**Report: Punchlist**  
**Function: Test, Adjust, & Balance**  
**Date: 12/16/2025**  
**Completed By: National TAB**

## 12-15-25 CULVERS BUSHNELL, FL (DOAS)

- Employee Bathroom Damper

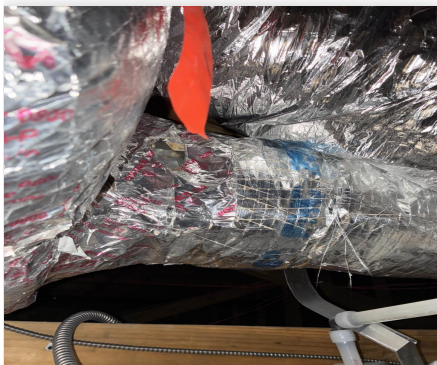
**Issue Name :** Employee Bathroom Damper  
**Description :** The damper controlling the diffuser in the employee bathroom off the kitchen is loose, and will not remain in the position needed to lower airflow to design.  
**Created By :** National TAB                      **Assigned To :** National TAB - Dan Hertenstein  
**Status :** Open  
**Priority :** Medium                                      **Asset Tag :**  
**Originated Date :** 12/15/2025 - Jackson Gunnels - National TAB
